**Department of Energy**  
 Office of Civilian Radioactive Waste Management  
 Yucca Mountain Site Characterization Office  
 P.O. Box 30307  
 North Las Vegas, NV 89036-0307

**U.S. DEPARTMENT OF ENERGY (DOE) RESPONSES TO U.S. NUCLEAR REGULATORY COMMISSION (NRC) COMMENTS ON DOE'S THERMOHYDROLOGY TESTING AND MODELING PROGRAM**

Reference: Ltr, Bell to Brocoum, dtd 1/23/97

## ENCLOSURE 1

Figure 1

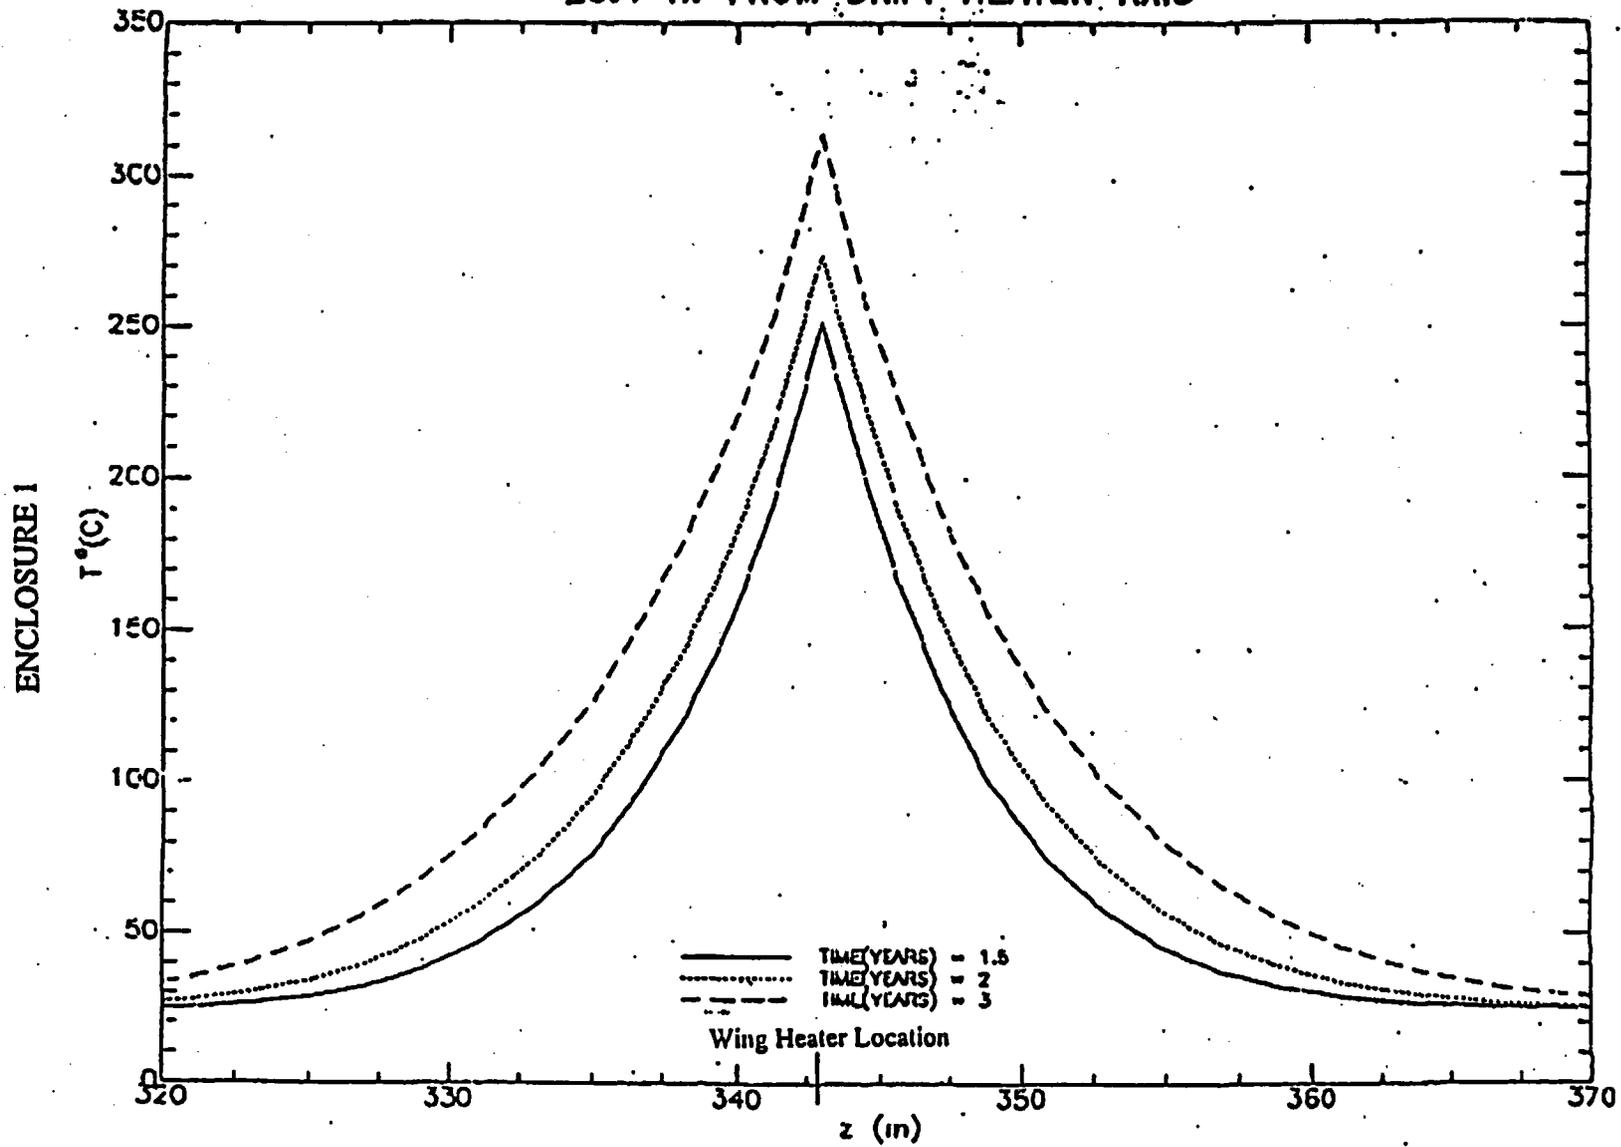
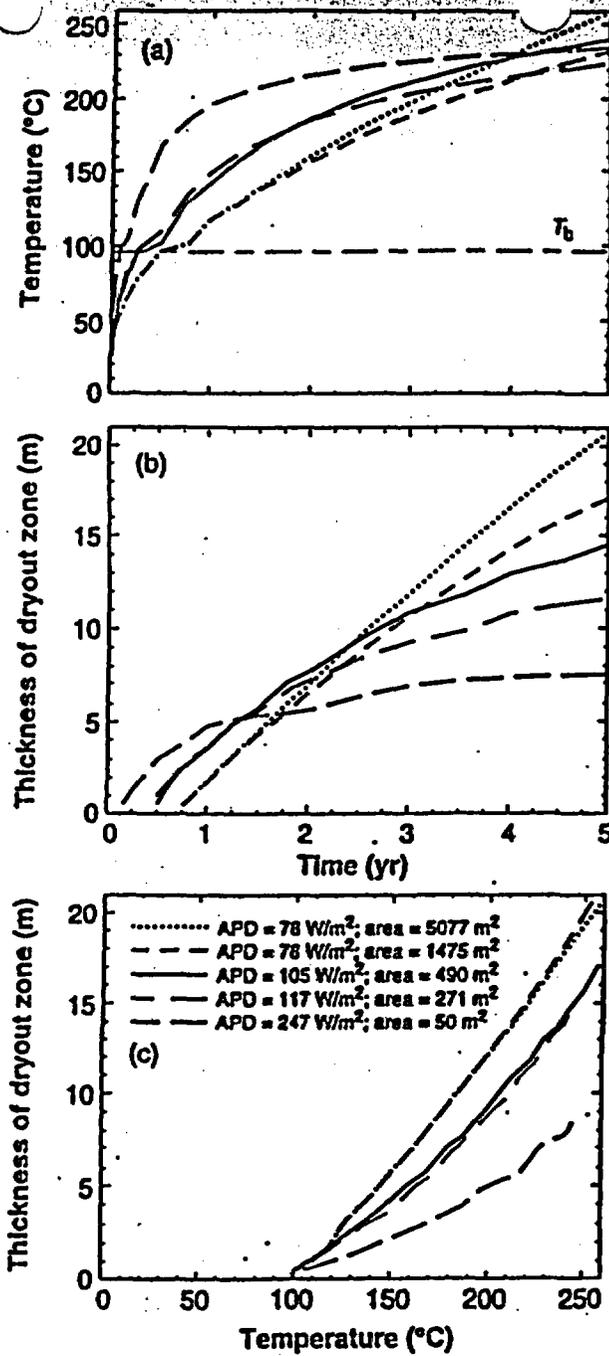
**“A field-scale heater test at thermal loads much higher than those expected at the repository poses a risk of masking the phenomenon of gravity-driven liquid water flow toward the heaters, which might occur at the lower temperatures expected for the repository.”**

Peak temperatures are predicted to occur only locally around the wing heaters (possibly as high as 350°C to 400°C based on a worst case (hottest), conduction-only, zero flux model) and are largely a function of the low thermal conductivity of the matrix of the repository rock (Topopah Spring Tuff). This same low thermal conductivity means that the effect is localized, as shown in Figure 1 (enclosed).

- The peak predicted rock temperature of 382°C occurs at the outer half of the wing-heater array, which is well away (about 7 meters) from the heated drift wall. Note that 382°C was determined with the use of a conduction-only model and a value of thermal conductivity ( $K_{th} = 1.67\text{W/m}^\circ\text{C}$ ) that is probably low for the DST area. With the use of a thermal-hydrological model and a percolation flux of 0.05 mm/yr, a peak rock temperature of 312°C is predicted for the hottest portion of the wing-heater array. If a percolation flux of 5 mm/yr is assumed, the peak temperature is only 222°C. Therefore, the higher temperatures at the wing heaters reported earlier are worst case scenarios. The relatively high temperatures around the wing heaters (as compared to the vicinity of the heated drift) are the result of: (1) attempting to drive condensate from the outer boiling region towards the heater drift and (2) the small diameter of the wing-heater boreholes. The relatively high temperatures are only applicable to the rock in the immediate vicinity of the outer wing heaters, which is well removed from the heated drift.
